POWER DISTRIBUTION

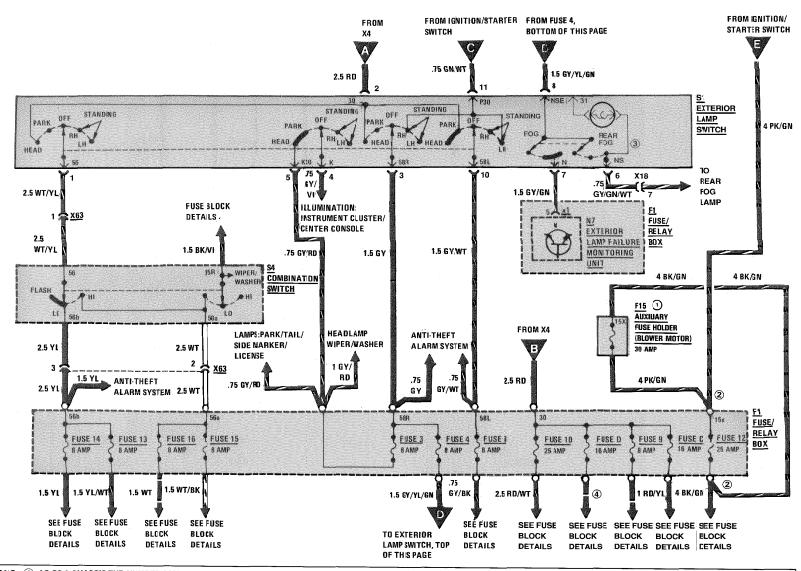
REVISIONS: ① AS OF A CHASSISEND NUMBER A292112, F023505

AS OF MODEL YEAR 1988, WIRED DIRECTLY THROUGH F15 (F12 NOT USED)

3 AS OF MY 1991

EXCEPT MODELS 400E/500E
